## PLANNING REPORT

### PLANNING AND ZONING COMMISSION

DECEMBER 11, 2008

1. **Dublin Jerome High School – Mounding** **8300 Hyland-Croy Road**  
**08-053AFDP** **Amended Final Development Plan**

# PROPOSED LANDSCAPE PLAN

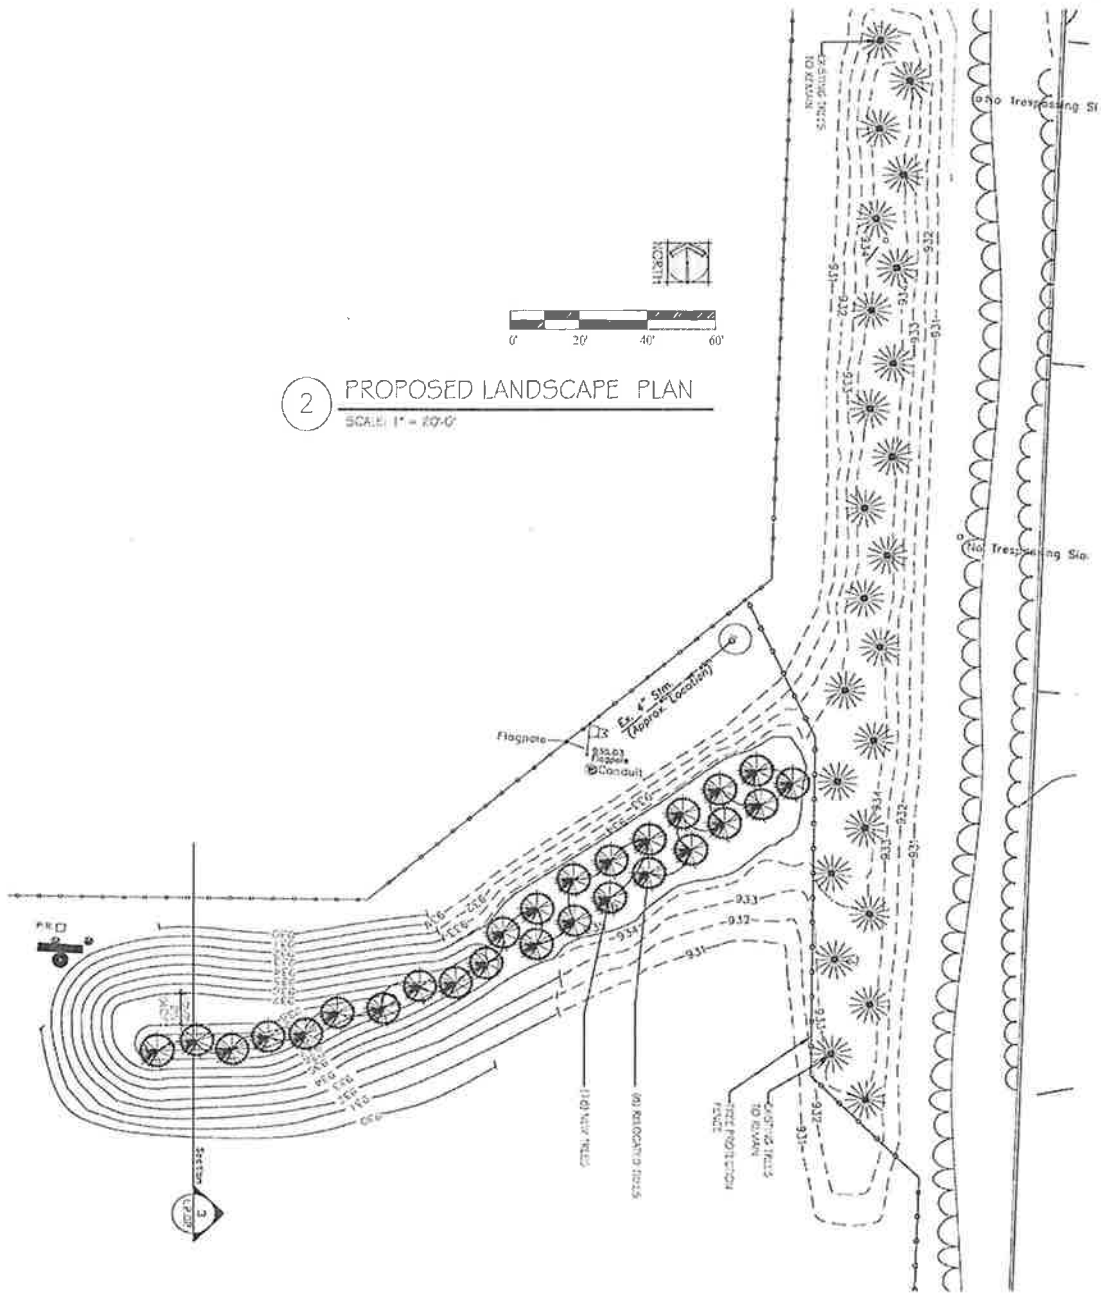
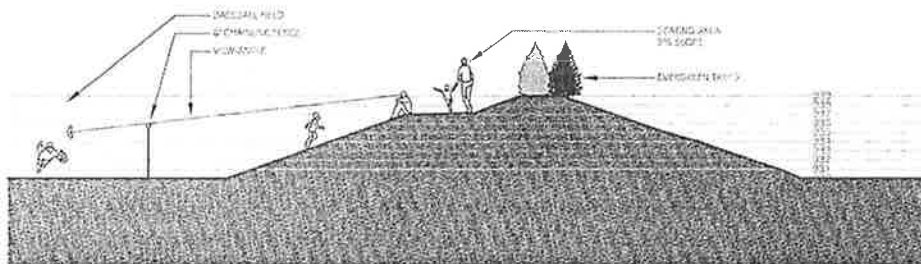
The applicant is proposing to install sixteen evergreen trees along the top of the centerfield portion of the mound in two staggered rows. Ten additional evergreen trees will be planted along the top of the proposed widened mound, which will aid in restricting spectators from the top of the mound.

**Criteria not met:** The proposal does not conform to the preliminary development plan requirement for appropriate landscaping as shown on the approved plan. While additional landscaping has been provided on the top of the mound to screen spectators and limit activity in this area, the intent of the approved amended final development plan was to prevent spectator activity in this area. The proposal provides for adequate storm drainage.
